**Independent Environmental Audit Report 9 (IA9)
Sydney Metro**

**Sydney Metro Western Sydney Airport (SSI 10051)
Finishing Auxiliary Works (FAW)
Footbridge St Mary's (FSM)**

Audit Date: 18 February 2026

Morasey Ref: MESYM: 2026106-02

Photos 1 & 2: LOR site compound; some litter from skip bins was observed

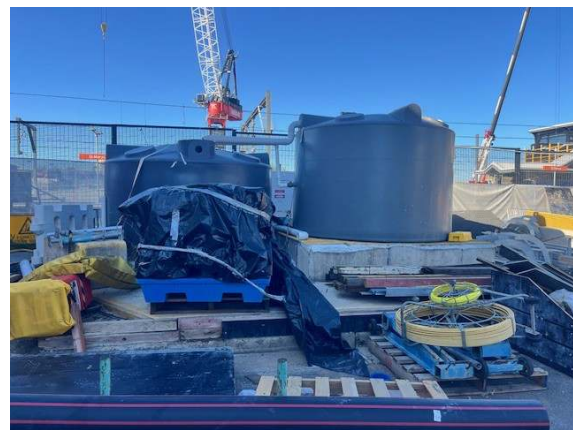
OBS2	C10	The CEMP and CEMP Sub-plans, as approved by the Planning Secretary or endorsed by the ER (whichever is applicable), including any minor amendments approved by the ER, must be implemented for the duration of construction.	Litter was observed overflowing from skip bins and around the site compound.	Clean up litter from the compound and ensure bins are emptied regularly, i.e. before they begin to overflow.	<p>Responsibility: LOR Environment Manager</p> <p>Due Date: Within 5 Days</p> <p>Status: OPEN</p>
OBS3	C13	The following Construction Monitoring Programs must be prepared in consultation with the relevant government agencies (as	Reference to Table 4-1 in Appendix B of the SM-WSA Staging Report Rev 12, 11/12/2025 should be updated to Table 4-3 to reference the new	Update the Staging Report accordingly.	<p>Responsibility: Sydney Metro Environment Manager</p> <p>Due Date: During the next review</p>

C9	Any of the CEMP Sub-plans to be approved by the Planning Secretary must be submitted to the Planning Secretary with, or subsequent to, the submission of the CEMP but in any event, no later than one (1) month before construction or where construction is staged no later than one (1) month before the commencement of that stage.	<ul style="list-style-type: none"> - AEW Footbridge St Marys CEMP, Rev 01, dated 15/5/2023 - SM-WSA AEW FSM CEMP Rev01 ER Endorsement, dated 25/5/2023 - AEW Footbridge St Marys CEMP Rev05, dated 18/6/2025 - SM-WSA AEW FSM CEMP Rev05 ER Endorsement, dated 20/8/2025 	C	ER approval of the WSA FSM CEMP was not within the current audit period. Compliance with Condition C9 was verified during a previous audit. The WSA FSM CEMP was approved by the ER in a letter dated 25/5/2023. Construction for WSA FSM commenced on 27/5/2023.
C10	Construction must not commence until the CEMP and all CEMP Sub-plans have been approved by the Planning Secretary or endorsed by the ER (whichever is applicable), unless otherwise agreed by the Planning Secretary. The CEMP and CEMP Sub-plans, as approved by the Planning Secretary or endorsed by the ER (whichever is applicable), including any minor amendments approved by the ER, must be implemented for the duration of construction.	<ul style="list-style-type: none"> - AEW Footbridge St Marys CEMP, Rev 01, dated 15/5/2023 - SM-WSA AEW FSM CEMP Rev01 ER Endorsement, dated 25/5/2023 - AEW Footbridge St Marys CEMP Rev05, dated 18/6/2025 - SM-WSA AEW FSM CEMP Rev05 ER Endorsement, dated 20/8/2025 - SM-WSA AEW FSM Biodiversity ERAP (CEMP, Attachment A) 	NC	DPHI approval of the original WSA FSM CEMP & Sub-plans was not within the current audit period. Compliance with Condition C10 was verified during a previous audit. The WSA FSM CEMP was approved by the ER in a letter dated 25/5/2023. Construction for WSA FSM commenced on 27/5/2023. The implementation of the CEMP was verified during the audit site inspection and as noted throughout the audit. Non-Compliance 1: There was no TPZ established around one of the trees in Laydown 1. The SM-WSA AEW FSM Biodiversity ERAP requires "Construction of fencing or any physical barrier between installation areas and the vegetation to be installed where required". Recommendation: Establish a TPZ around the affected tree in Laydown 1 in accordance with the Biodiversity ERAP. Observation 2: Litter was observed overflowing from skip bins and around the site compound. Recommendation: Clean up litter from the compound and ensure bins are emptied regularly, i.e. before they begin to overflow.
